USB Type-C ENGINEERING CHANGE NOTICE

Title: USB Type-C ECR on the SRC-to-TrySRC looping
Applied to: USB Type-C Specification Release 1.1, April 3, 2015

Figure 4-16 Connection State Diagram: DRP with Accessory and Try.SRC Support

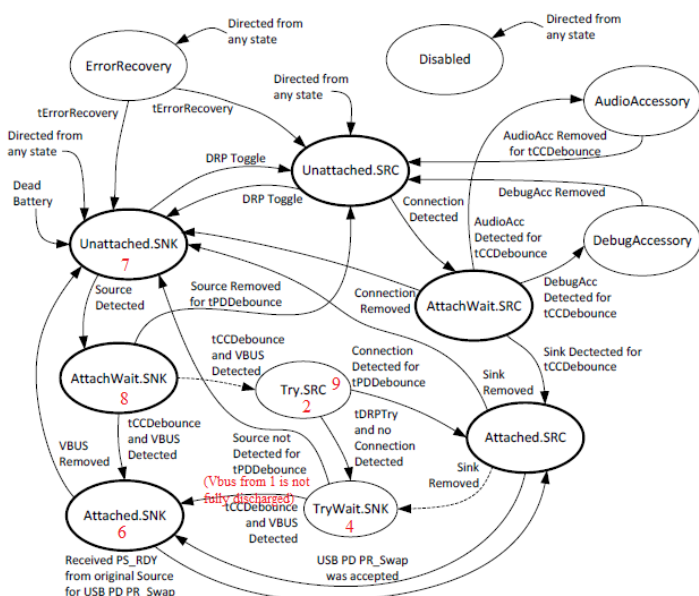
If a Type-C Source has a long tVBUSoff delay, the Source may not connect with a Try.SRC machine.

First, when Source outputs the VBUS (1) and Try.SRC DRP will enter Try.SRC (2). As Rd of Try.SRC DRP is removed, Source enters Unattached.SRC (3). After tDRPtry, no connection can be made and Try.SRC DRP enters TryWait.SNK (4) and Source enters AttachWait.SRC (5).

If the residue voltage of VBUS from (1) is still not fully discharged, Try.SRC DRP will enter Attached.SNK (6) but Source cannot enter Attached.SRC as Vsafe0V is required. After VBUS is further discharged, Try.SRC DRP will enter unattached.SNK (7) & AttachedWait.SNK (8) and Source will finally enter Attached.SRC (7*) and start to output VBUS again. Try.SRC DRP returns to Try.SRC (9).

The two machines return to the original (1) and (2) states. And loop forever.

As a DRP will always leave Attached.SNK if VBUS is removed without any delay, it is necessary to ensure that the DRP entering Attached.SNK is due to VBUS supplied by the Source but not the discharging residue voltage in capacitor. A condition can be added to ensure VBUS is fully discharged once, and the detected VBUS (to enter Attached.SNK) is supplied by Attached.SRC.

The port shall transition to TryWait.SNK after tDRPtry and the SRC.Rd state has not been detected and VBUS is within vSafe0V, or after tTryTimeout and the SRC.Rd state has not been detected.
